SLOVENSKI STANDARD
SIST EN 61429:2001/A11:2001
01-februar-2001

Marking of secondary cells and batteries with the international recycling symbol ISO 7000-1135 and indications regarding directives 93/86/EEC and 91/157/EEC

**Marking of secondary cells and batteries with
the international recycling symbol ISO 7000-1135 and
indications regarding directives 93/86/EEC and 91/157/EEC**

This amendment A11 modifies the European Standard EN 61429:1996; it was approved by CENELEC on 1998-04-01. CENELEC members are bound to comply with the CEN/CENELEC Internal Regulations which stipulate the conditions for giving this amendment the status of a national standard without any alteration.

Figure 2 - EC-symbol of a crossed through roll out container

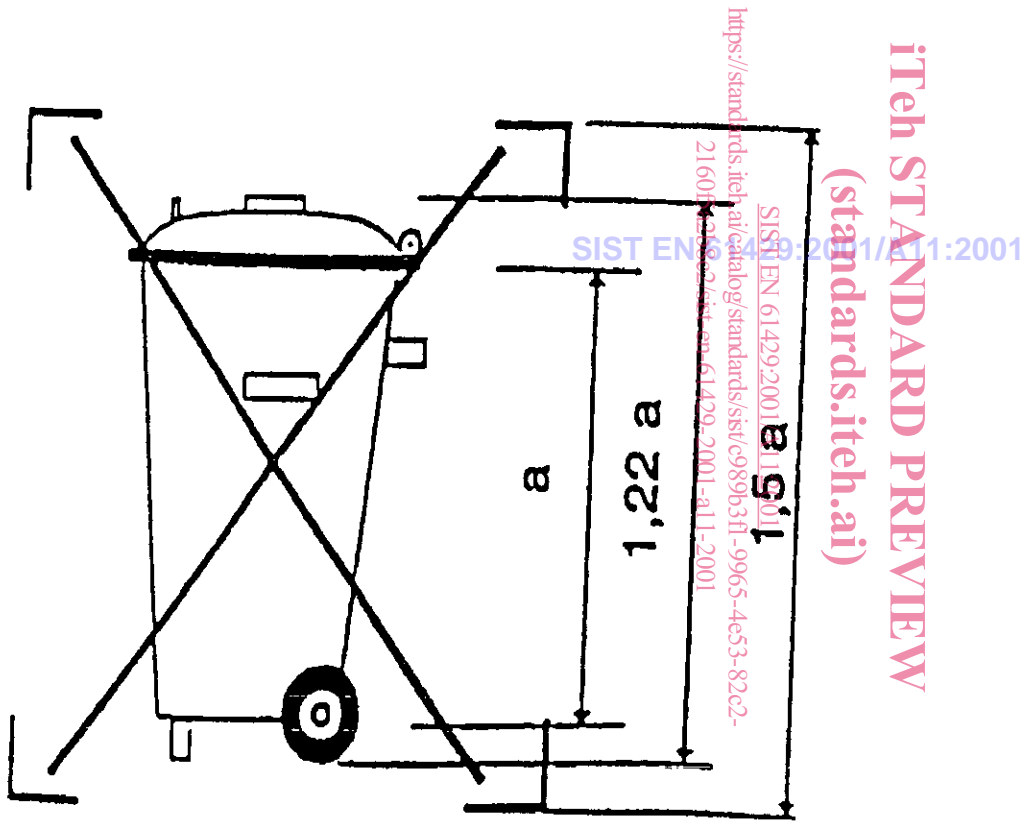
Add : "Figure 2 EC-symbol of a crossed through roll out container".

Replace figure 2.

"3.2.2 Indication of the EC-symbol of a crossed through roll out container

The container symbol shall cover at least 3% of the area of the largest side of the battery up to a maximum size of 5 x 5 cm. »

Fig.3 - Disposition of the recycling symbol with the EC-symbol and the chemical symbol

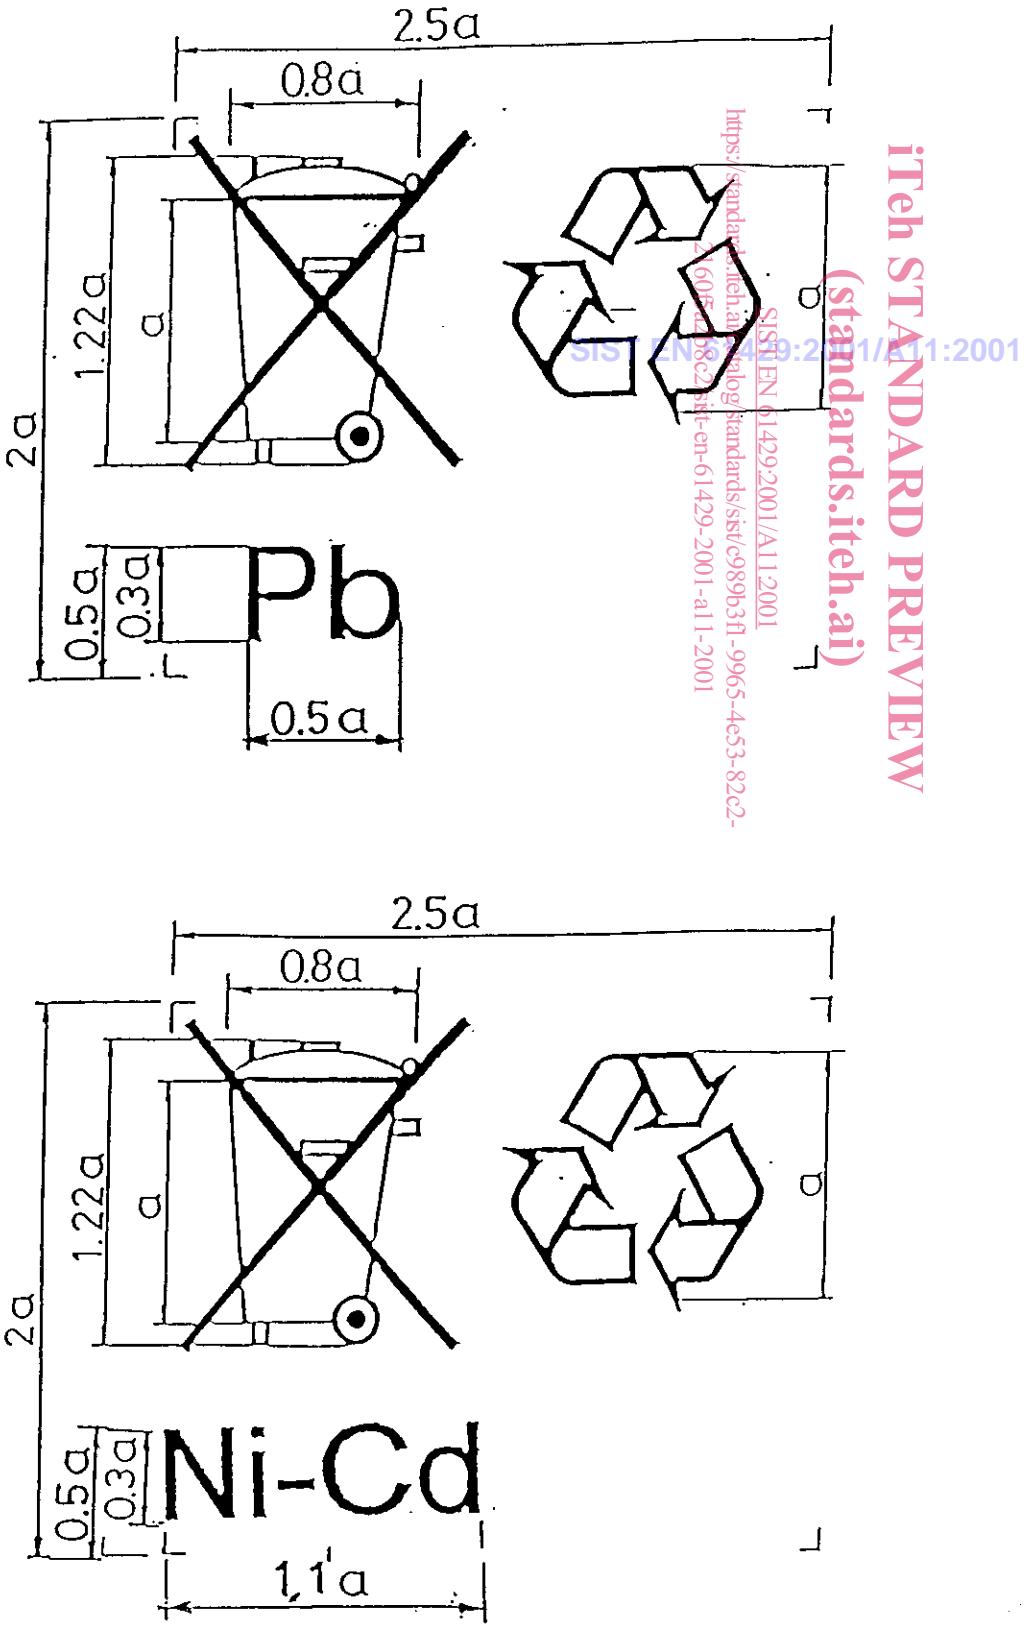
Change the 2nd sentence in : "They shall be placed beneath the crossed through roll out container (see figure 3 and 4)."

Add new figures 3 and 4.
